### **PUBLIC HEARING III MEMORANDUM**

**528 Boylston Street**

Subject: 528 Boylston Street 40B Design Review (Memo #2)

**Re: Proposed Multifamily Residential Development Transportation Peer Review**

Alternate Proposal with 10' setback and reduced parapet

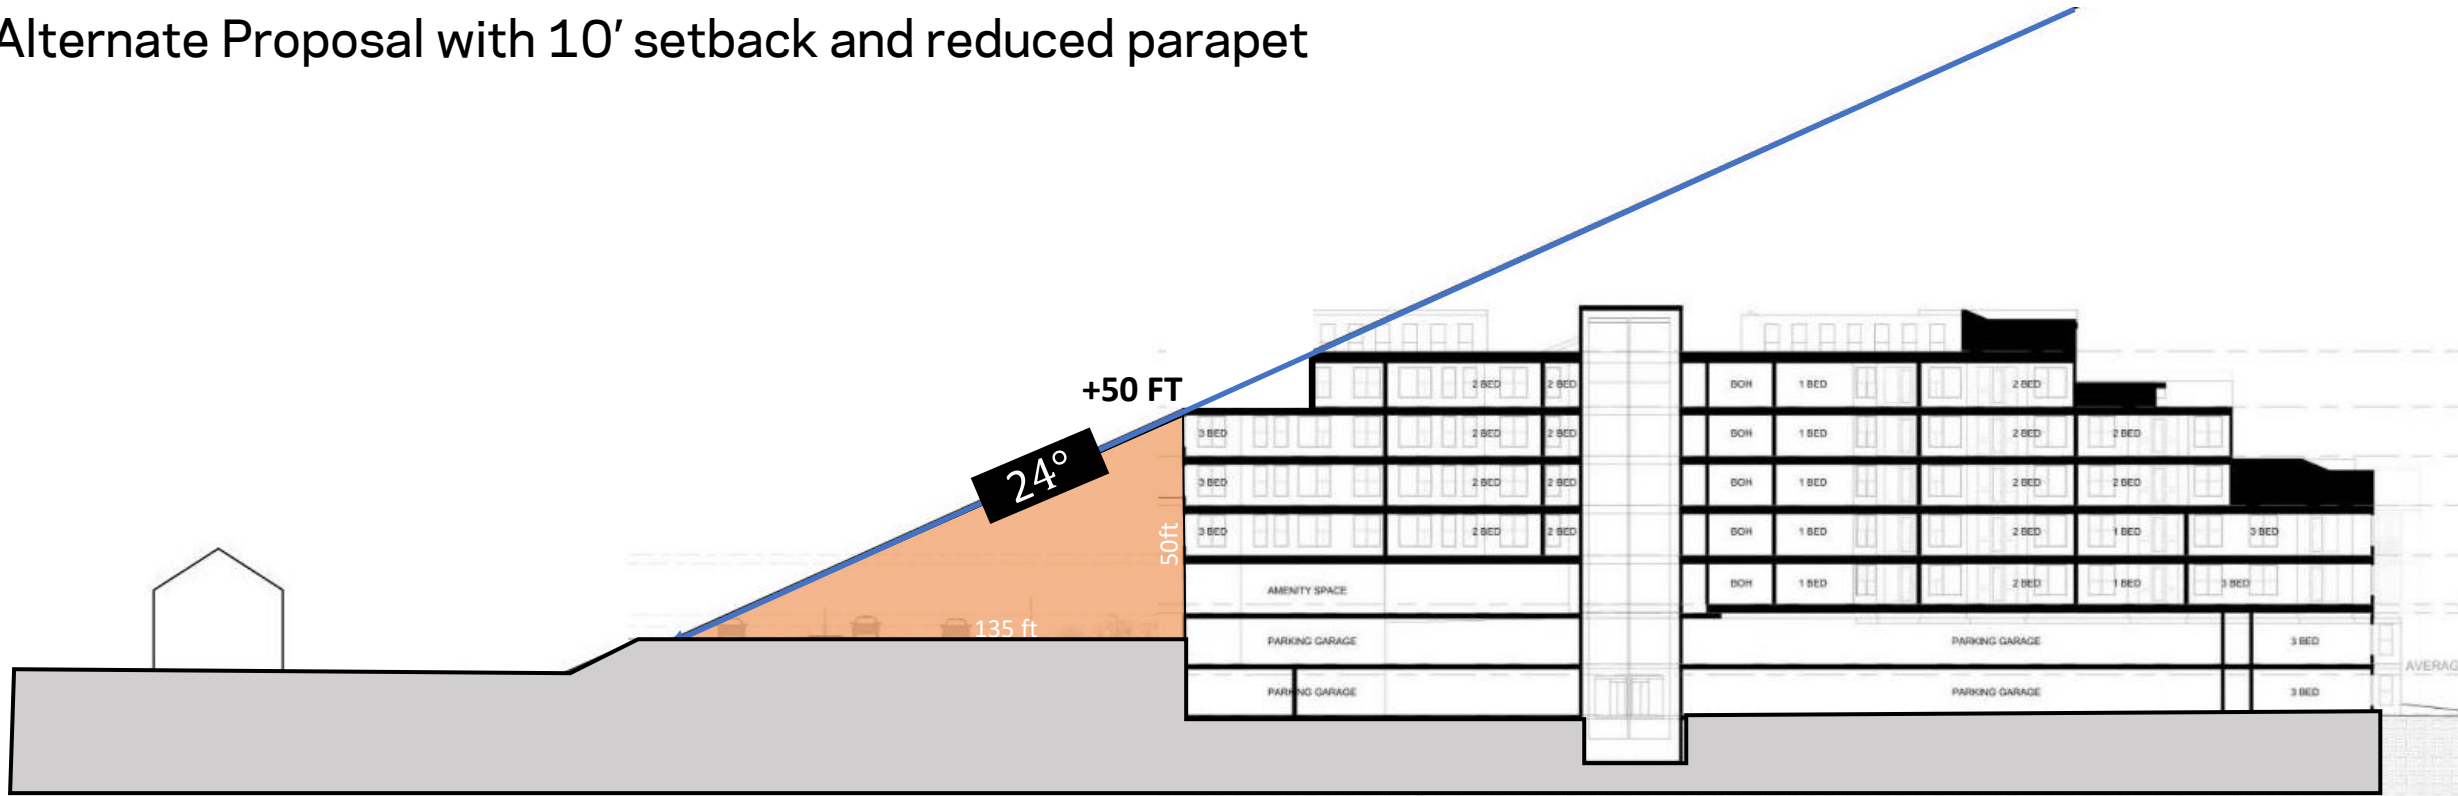
3. Reconsider the design of the gable roof parapet elements. While we understand that these are intended to screen rooftop condensing units, we have concerns about the added bulk (additional 10' of height) and shadow implications along Boylston Street. [\[see pages 22-30 in attached document\]](#)

Alternate Proposal with 10' setback and reduced parapet
